West Capital Airpark Phase 1B-2 Residential (Novatech Phase 2B) Servicing Report

West Capital Airpark – Phase 1B-2 Residential
1500 Thomas Argue Road
Ottawa, Ontario
Servicing Report

**Reference: West Capital Airpark – Phase 1B-2 Residential
Site Servicing Report
Our File No: 102085
City File No.: D07-16-22-0017**

This report has been revised to address comments from the City of Ottawa as indicated in the cover letter. The City review comments and response to comments are included in **Appendix A** for reference.

City of Ottawa Stormwater Operations Comments Received via email attachment June 13, 2024

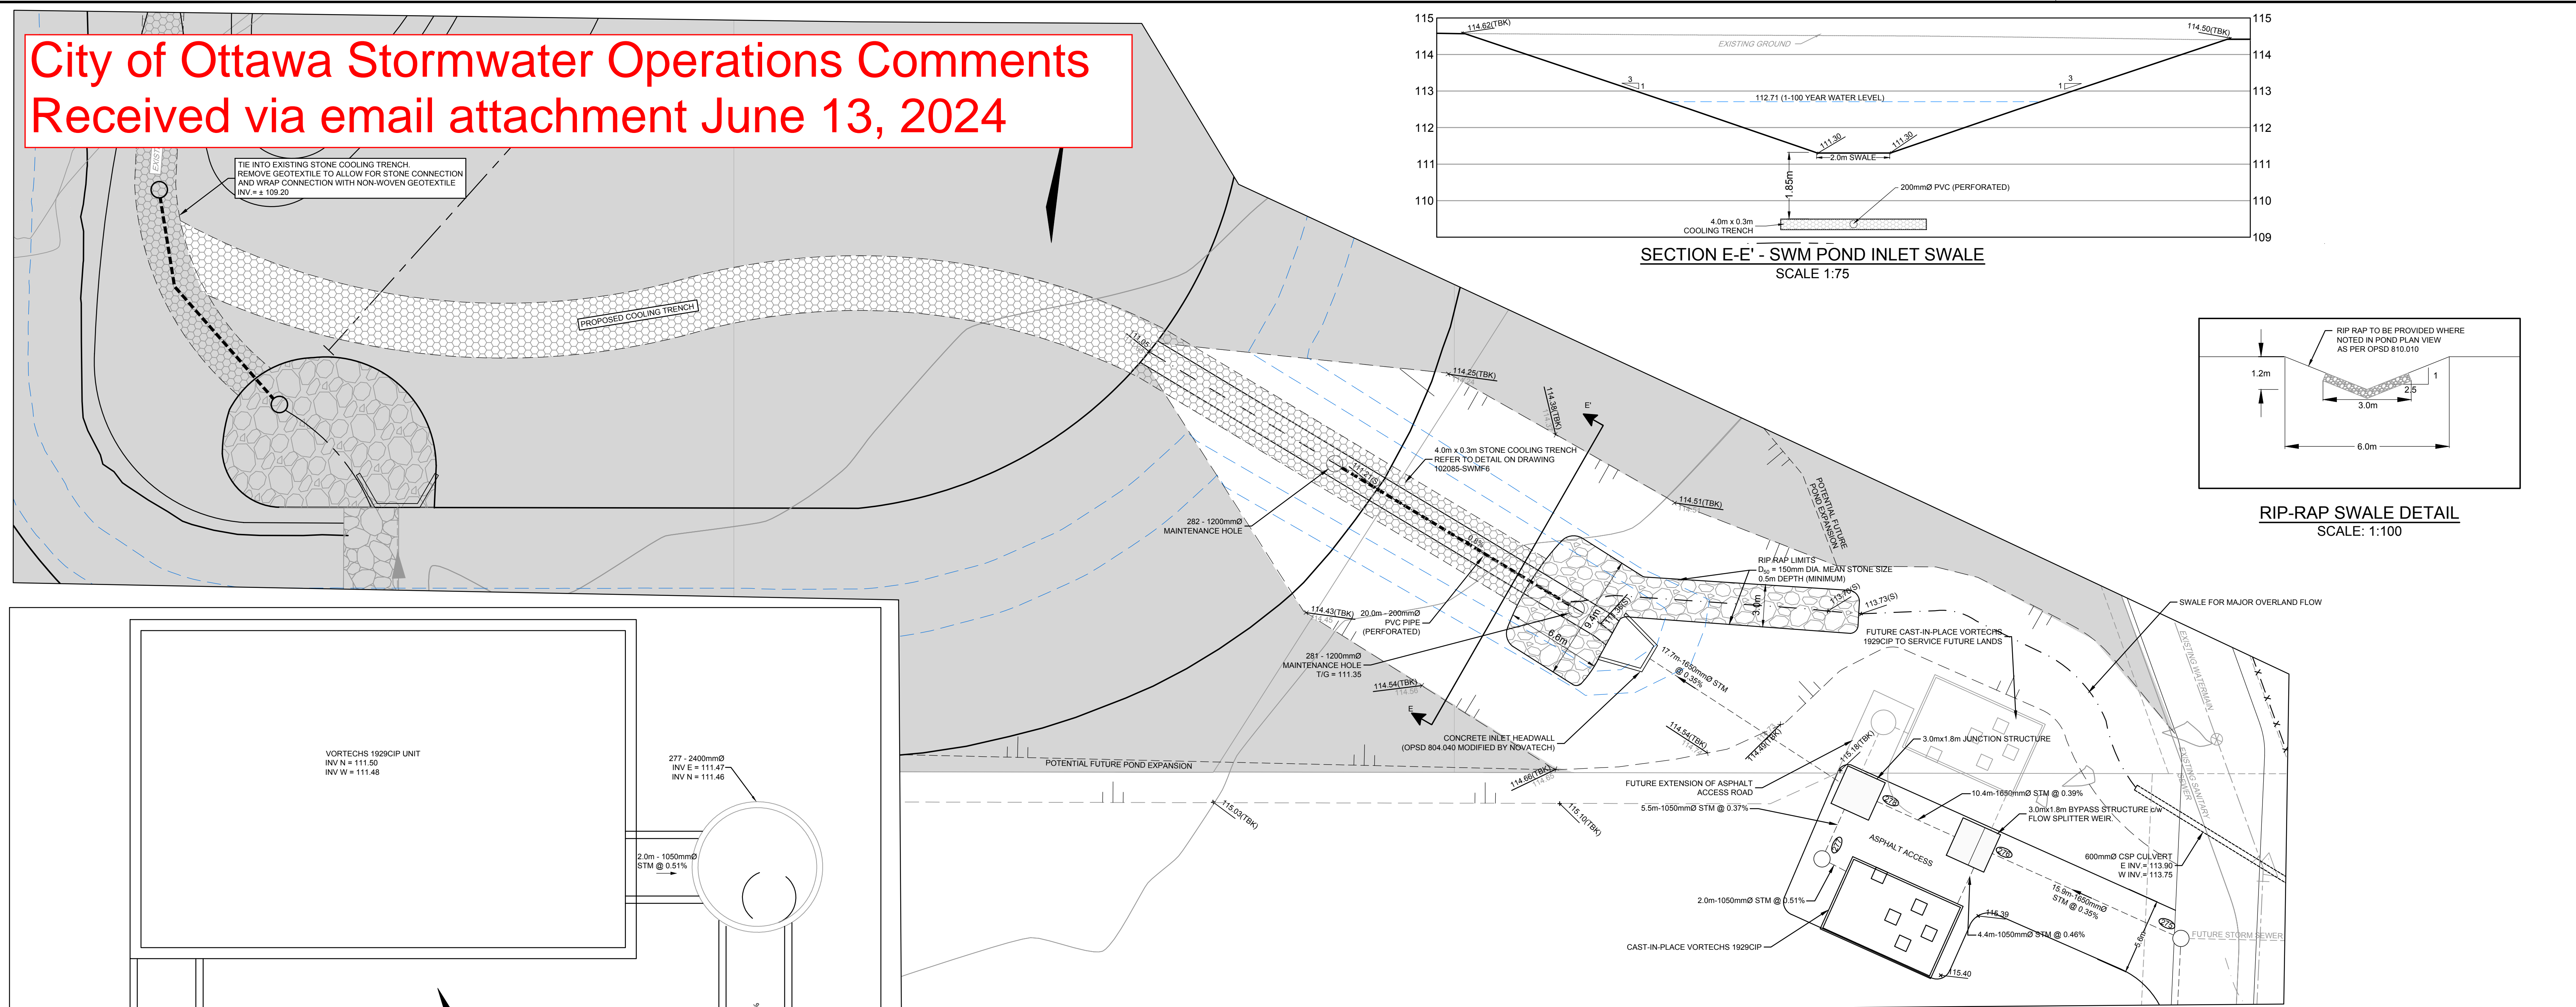
5	Who will be responsible for maintaining the rear yard infiltration trench while it's in the place? Please provide a service road parallel to the trench.	Maintenance of the rear yard infiltration trench would be the responsibility of the homeowners. This is consistent with standard City of Ottawa projects with a rear yard subdrain / infiltration system. Outlet catchbasins have been proposed within the ROW as part of the rear yard infiltration system and would provide maintenance access to the infiltration trench.No service road will be provided through the residential rear yards.	OK
6	Lastly the off-line Oil Grid separators must be provided with the gate to provide efficient maintenance.	The Stormwater Management Facility is a dry pond system and will not require the installation of gates in order to access the oil-grit separator for maintenance.

The sluice gates or stoplogs are required to isolate the OGS unit during the cleanup process

PROJECT No. 1020852
REV # 10
DRAWING No. 102085-GP14

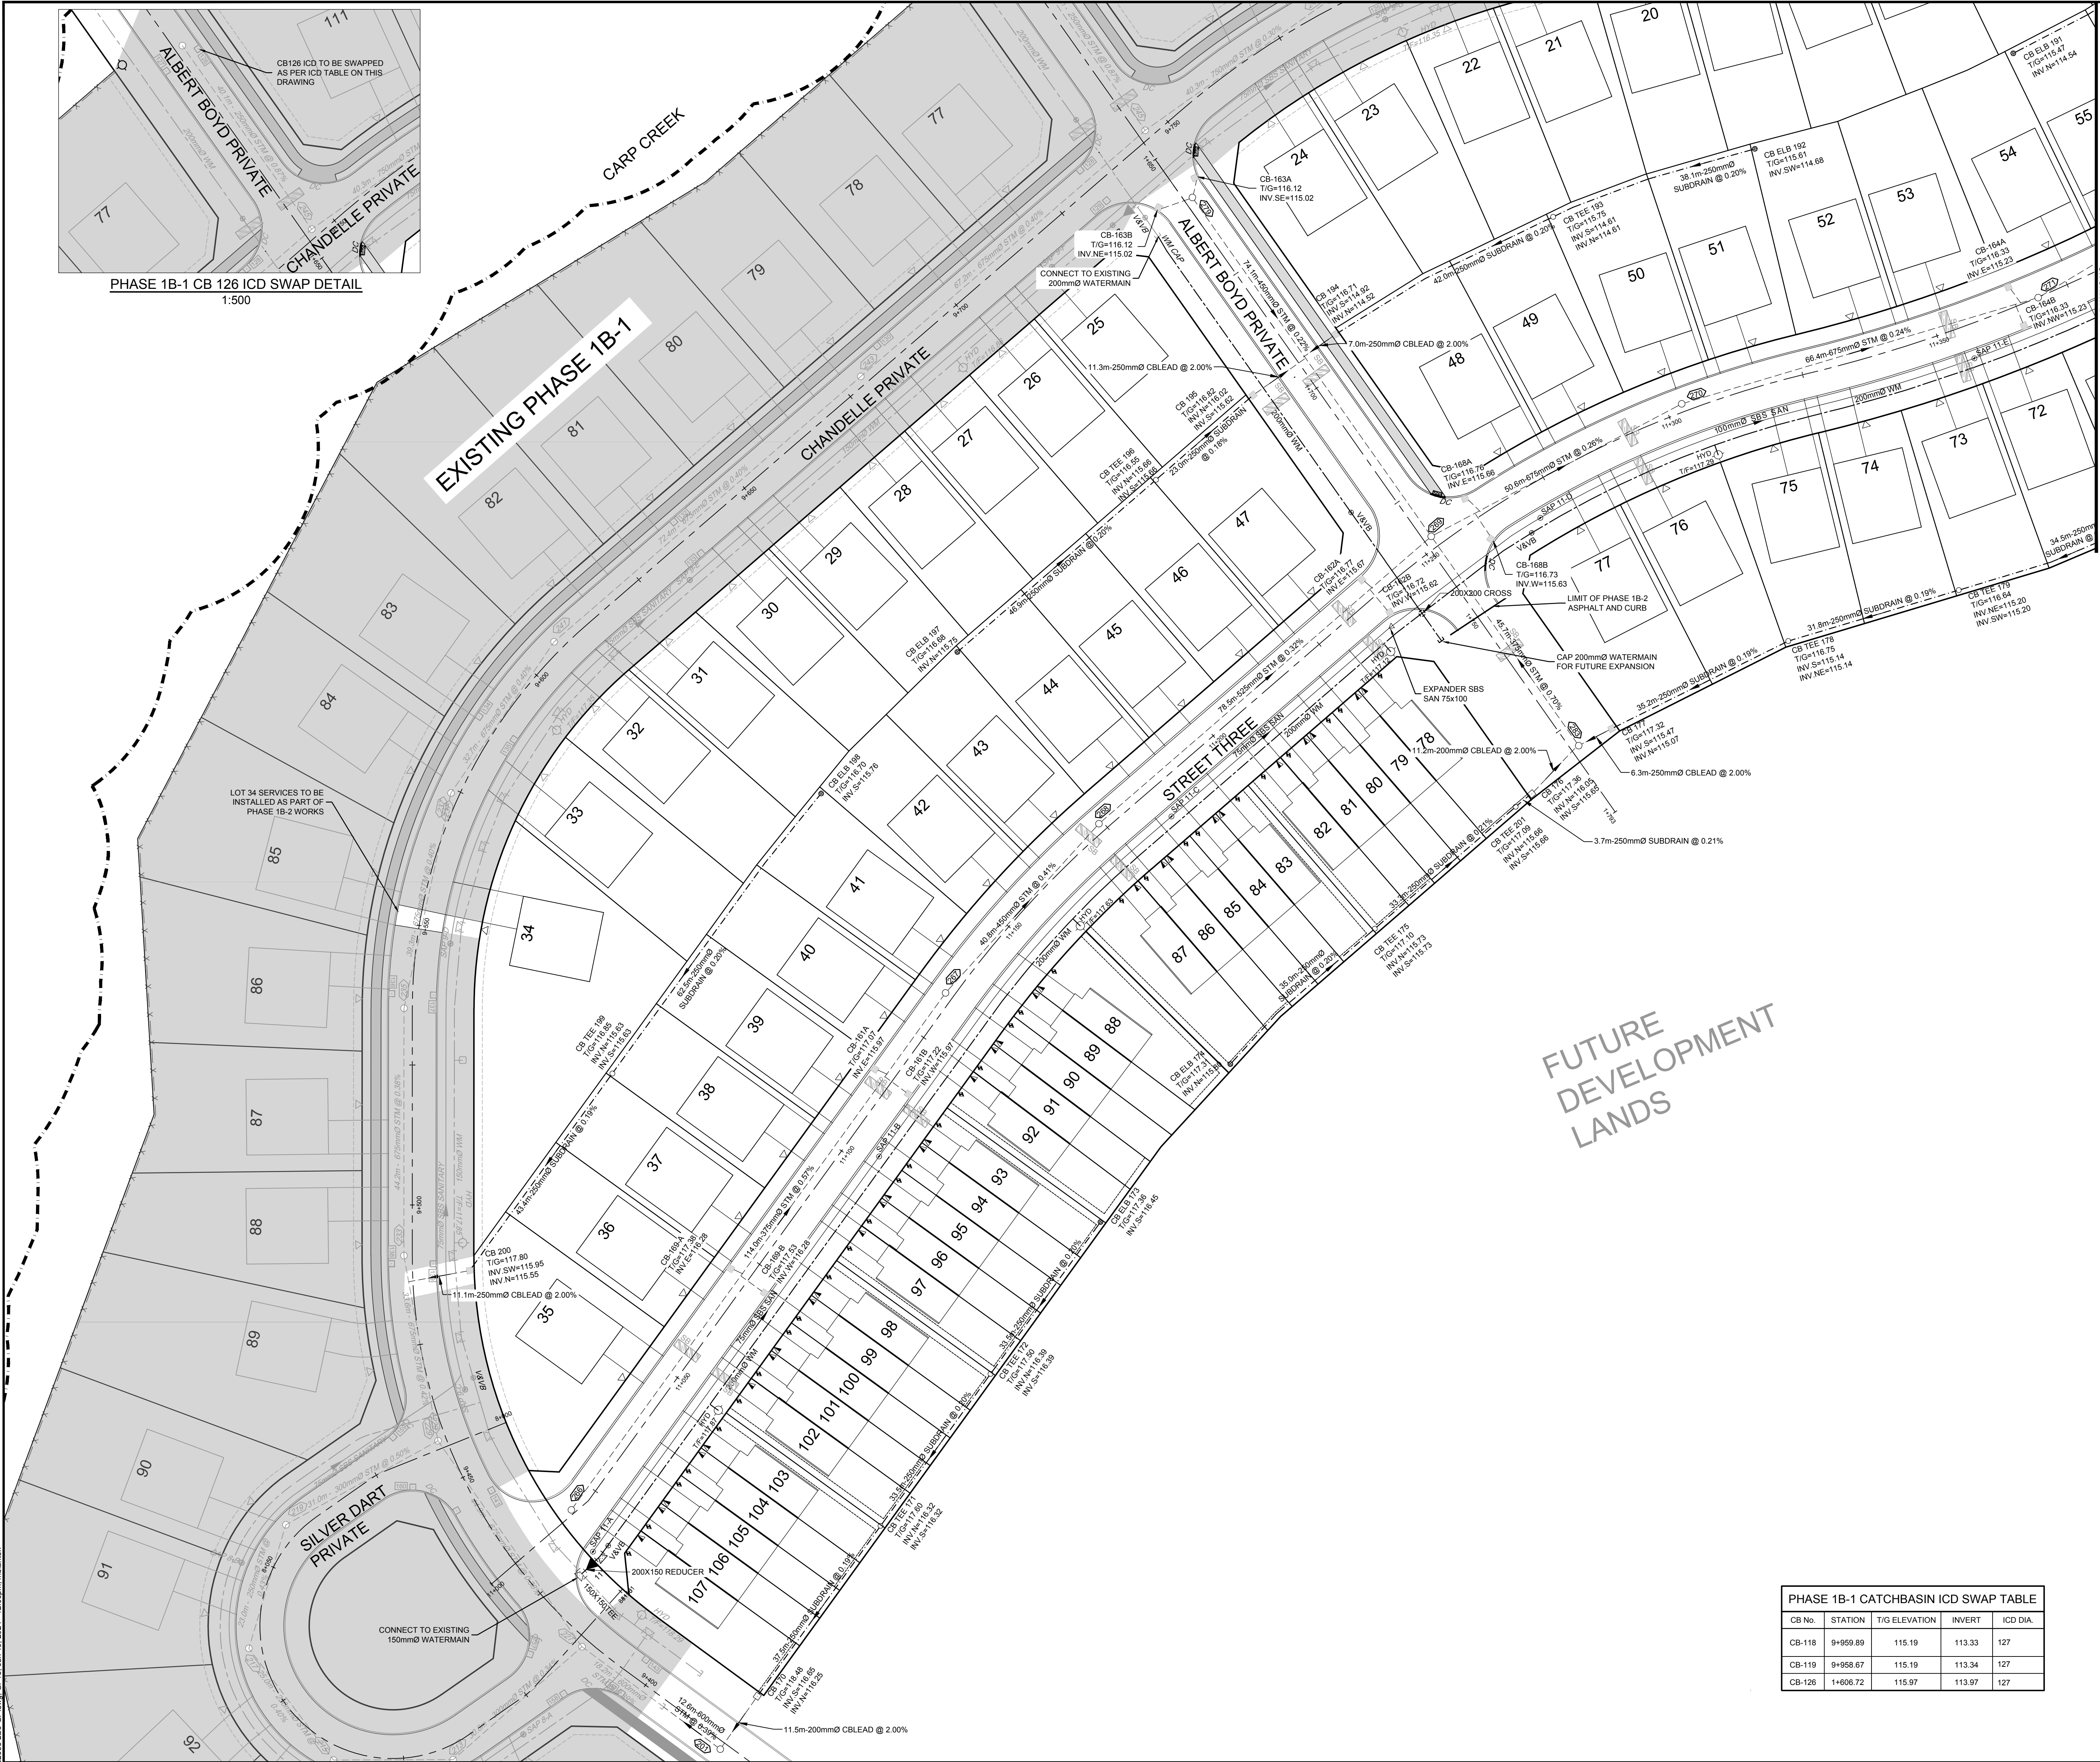
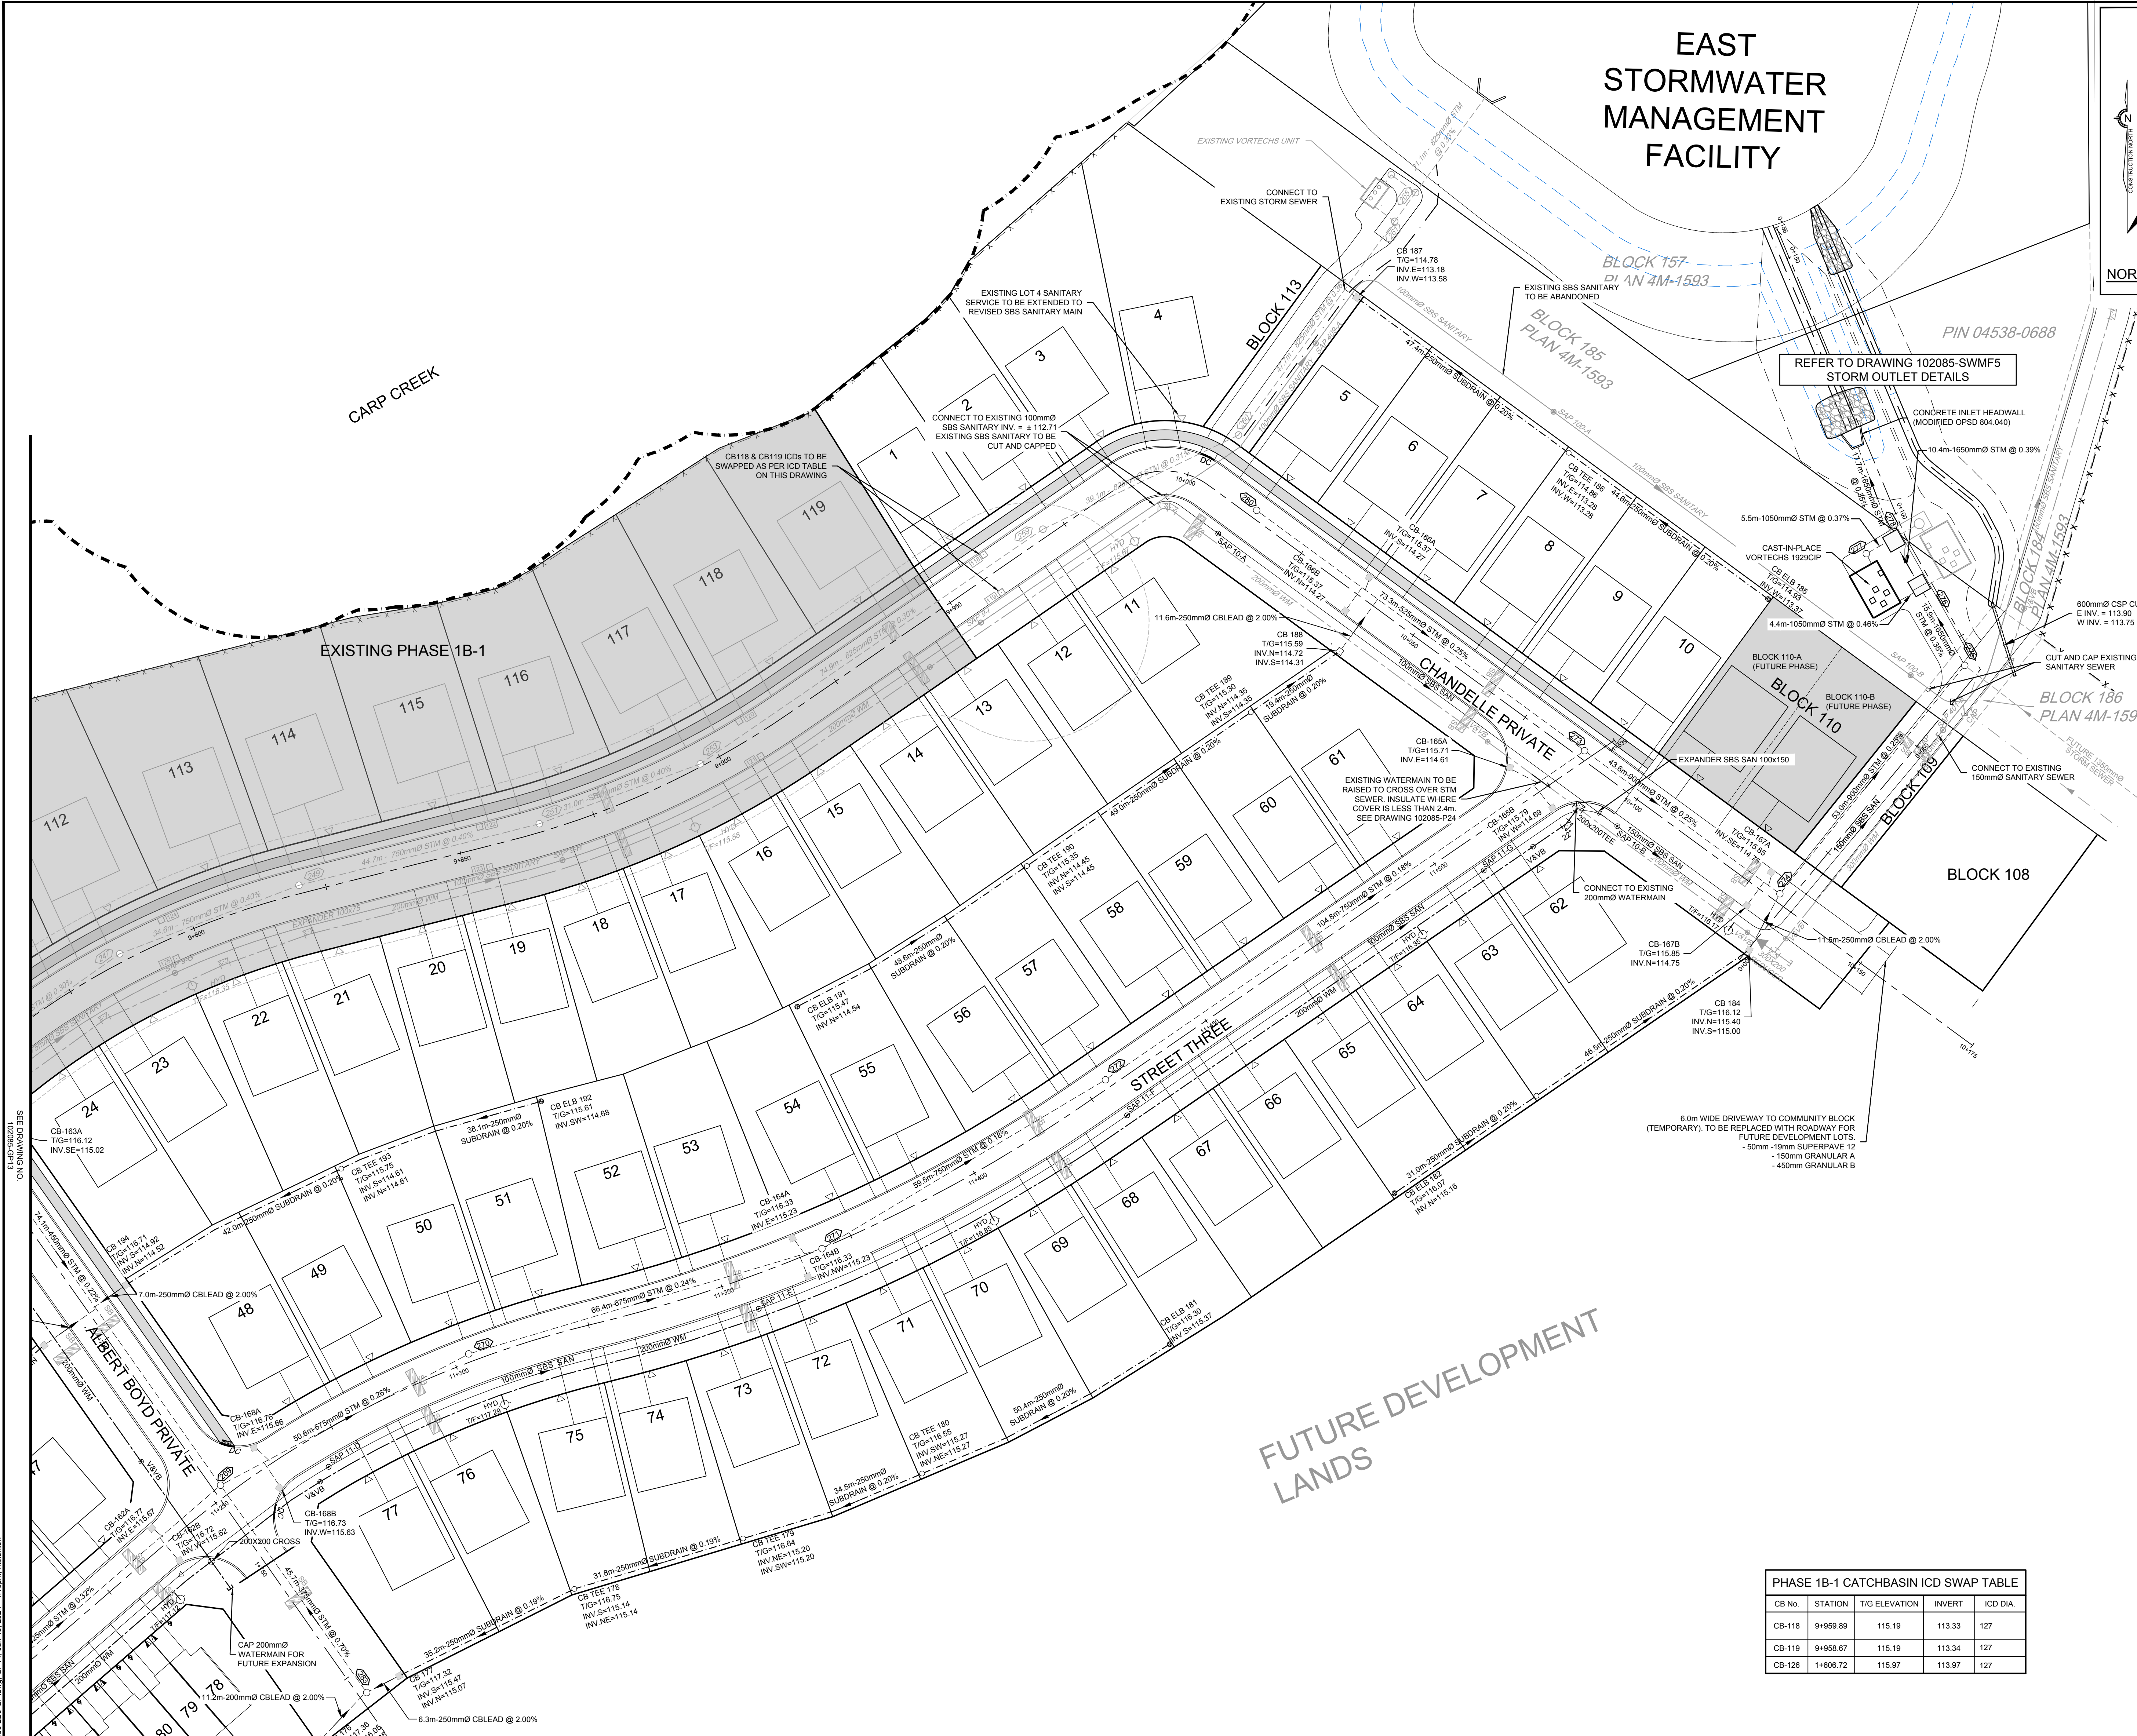
7.	Drawing shows cb 119 and 118 to be swapped while table 2 indicates that cb's to be swapped 126 and 127 (can't locate these 2 cb's) and icd's in each of cb 138 and 139. Can't find these two locations in	Drawing 102085-GP13 has been revised to indicate the location of CB 126 and CB 127. CB 138 and CB 139 are shown on drawing 102085-GP13 at	No further comment.
